[Docket No. 2000-NM-94-AD; Amendment
39-11712; AD 2000-09-04]

Airworthiness Directives; Boeing Model 767 Series Airplanes Equipped with General Electric Model CF6-80C2 Series Engines

ACTION: Final rule; request for
comments.

Electro-Mechanical Brake and CDU Cone Brake Torque Check
Figure 1

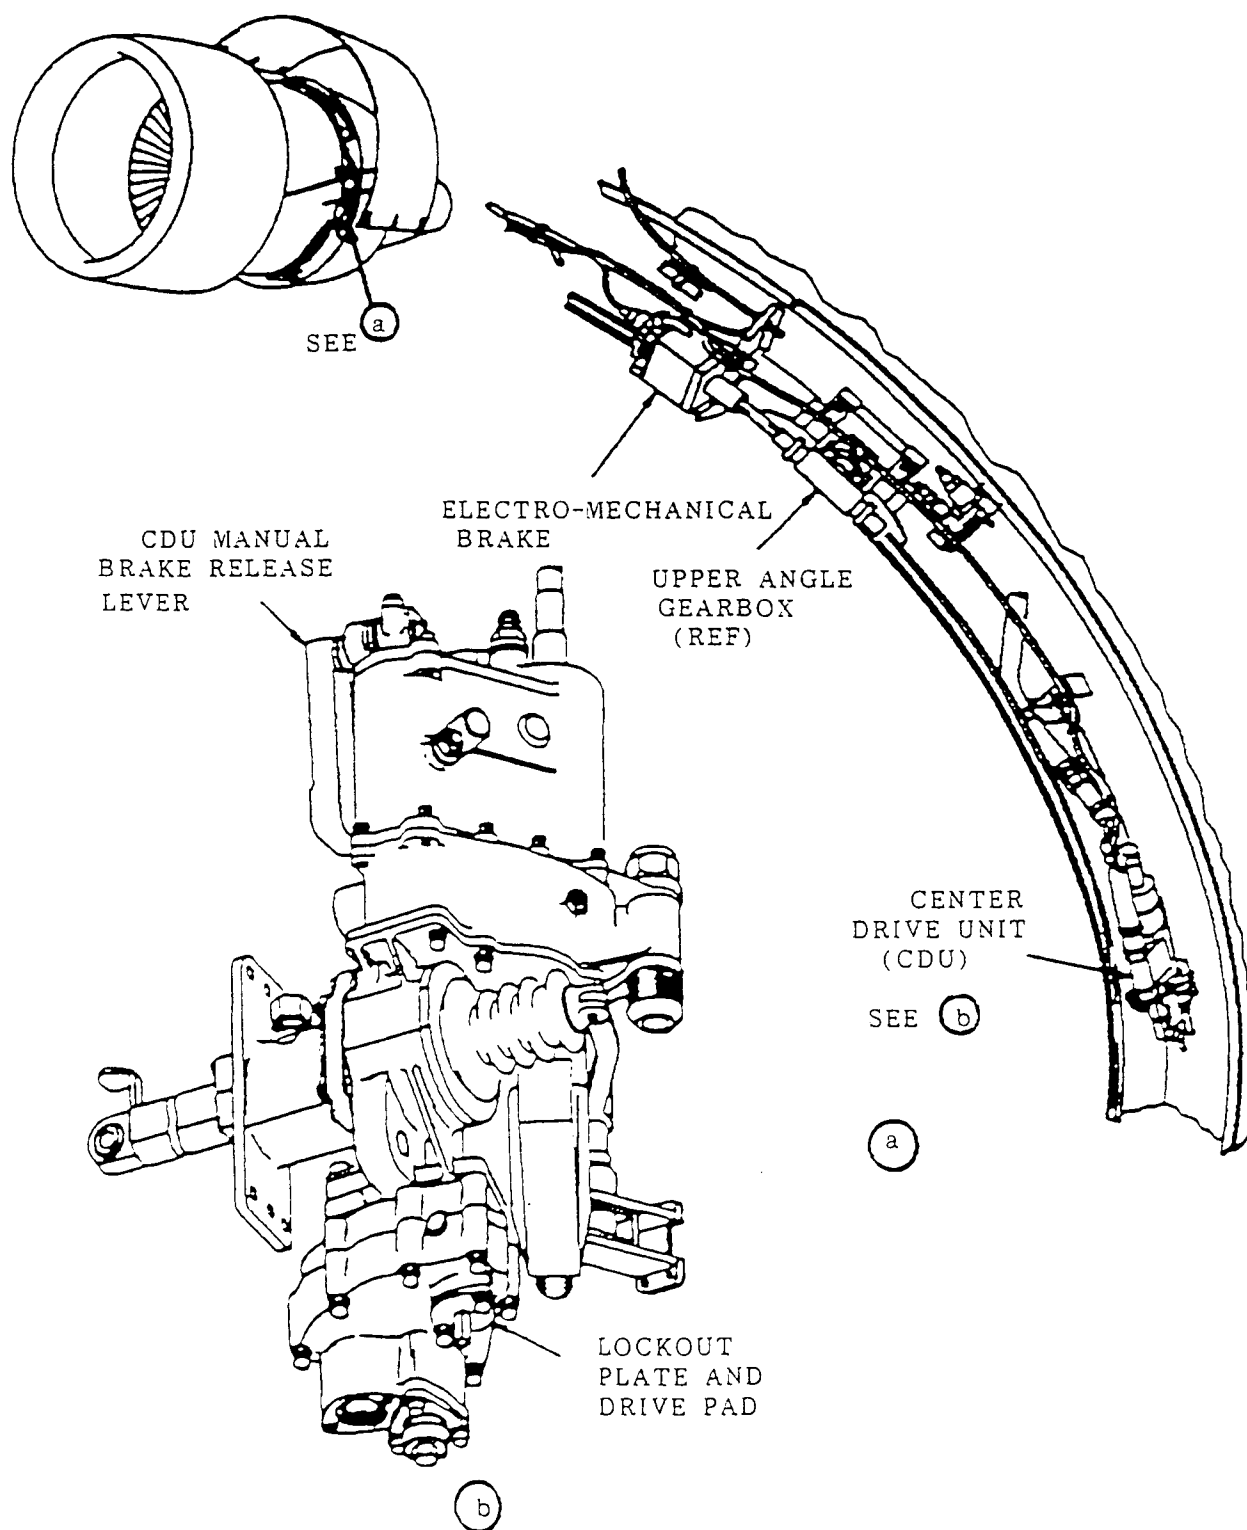
Since the issuance of AD 2000-02-20, the FAA has received information indicating that the functional test that is described in Boeing Service Bulletin 767-78A0081, Revision 1, is not applicable to Model 767 series airplanes having a third locking system installed on the thrust reversers. For those airplanes, an additional step is necessary in order to unlock the electro-mechanical brake, prior to accomplishment of the functional test, as described in Appendix 1 (including Figure 1) of the existing AD. If the test is performed on airplanes with the third locking system installed, in accordance with the service bulletin, the system

will always pass the test, even if the cone brake has failed. Paragraph (d) of the existing AD does not specifically list which airplanes are required to do the functional test of the cone brake of the CDU, in accordance with Boeing Service Bulletin 767-78A0081, Revision 1; and which are required to do the test in accordance with Appendix 1 (including Figure 1) of the AD. Therefore, paragraph (d) of this AD has been revised to separate the service information requirements for accurate accomplishment of the functional test.

In addition, the grace period of 650 flight hours to accomplish the functional test of the cone brake of the CDU is expected to expire for most airplanes by May or June 2000. For airplanes that have been modified to incorporate the third locking system, this would allow accomplishment of an invalid test with potentially misleading results. The valid functional test as described in Appendix 1 (including Figure 1) of this AD imposes no additional burden.

(2) For airplanes on which the modification required by paragraph (c) of this AD or a production equivalent has been accomplished: Perform the test in accordance with Appendix 1 (including Figure 1), sections 1.A.(2), 2.A., 2.C., and 2.D; of this AD. Accomplish the test at the time specified in paragraph (d)(2)(i) or (d)(2)(ii) of this AD, as applicable.

production, or within 1,000 flight hours after March 9, 2000, whichever occurs later: Perform operational checks of the electro-mechanical brake in accordance with Appendix 1 (including Figure 1); sections 1.A.(1), 2.A., 2.B., and 2.D; of this AD. Repeat the operational checks thereafter at intervals not to exceed 1,000 flight hours.

2. Electro-Mechanical Brake and CDU Cone Brake Torque Check (Fig. 1)

(1) The electro-mechanical brake system is working correctly if the torque is reached before you turn the wrench 450 degrees (1 1/4 turns).

(2) If the flexshaft turns more than 450 degrees before you reach the specified torque, you must replace the long flexshaft between the CDU and the upper angle gearbox.

(3) If you do not get 90 pound-inches of torque, you must replace the electro-mechanical brake.

(a) If the torque is less than 15-pound-inches, you must replace the CDU.
